UNITED STATES PATENT AND TRADEMARK OFFICE

APPLICATION NO.	FILING DATE	FIRST NAMED INVENTOR	ATTORNEY DOCKET NO.	CONFIRMATION NO.
10/520,663	02/03/2005	Keiji Otaki	122381	9411

Office Action Summary

DETAILED ACTION

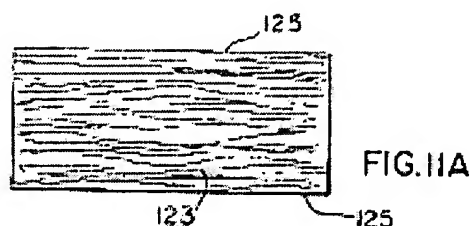
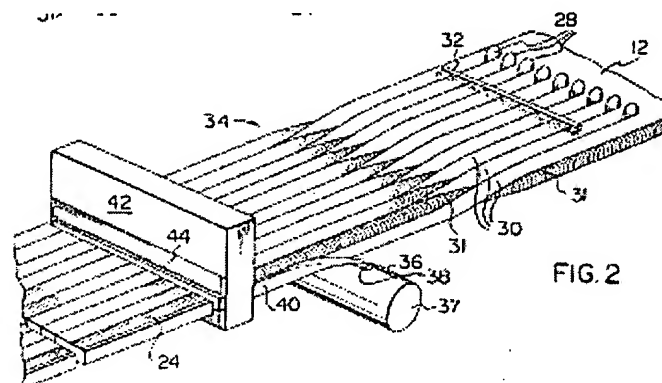
Regarding claim 1, Cameron ('793) teaches a mat-shaped thermal insulator made of inorganic fiber (*col. 4, ll. 31-33 and FIG-2, #12*), wherein at least a part of inorganic fibers is built-up in a direction parallel to lateral surfaces of the insulator (*col. 5, ll. 9-11 and col. 8, ll. 41-45 and FIG-11A, #123*), and

Regarding claim 2, Cameron ('793) teaches an insulator wherein the lateral surfaces of the insulator are inclined (*col. 5, ll. 18-21 and FIG-2, #31*).

Regarding claims 3 and 9, Cameron ('793) teaches an insulator wherein longitudinal cuts are formed on the lateral surfaces of the insulator (*col. 5, l. 20, FIG-2, cutters #28*).

Regarding claims 4, 10 and 11, Cameron ('793) teaches an insulator wherein at least one of the surfaces of the insulator is coated by a facing material (*col. 5, ll. 63-66 and FIG-2, #36*).

FIG. 8

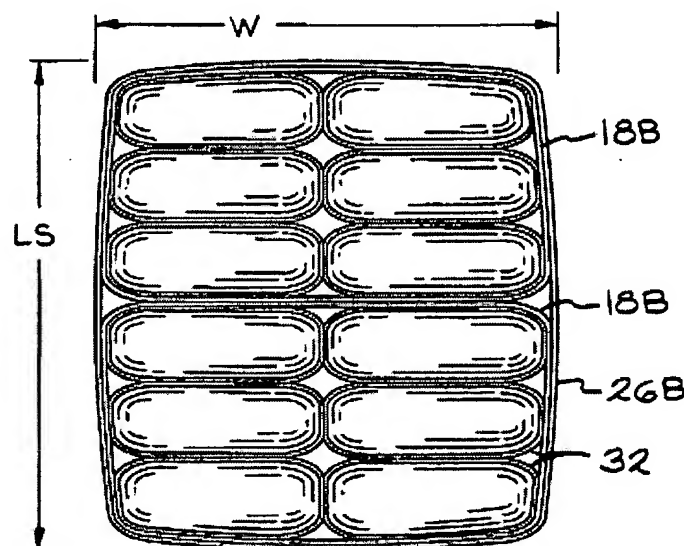
However, Berdan, ('063) teaches a package and wherein the package comprises a packaging bag (col. 1, ll. 18-20 and FIG-8) for the purpose of purpose of reducing transportation costs (col. 1, ll. 14-18).
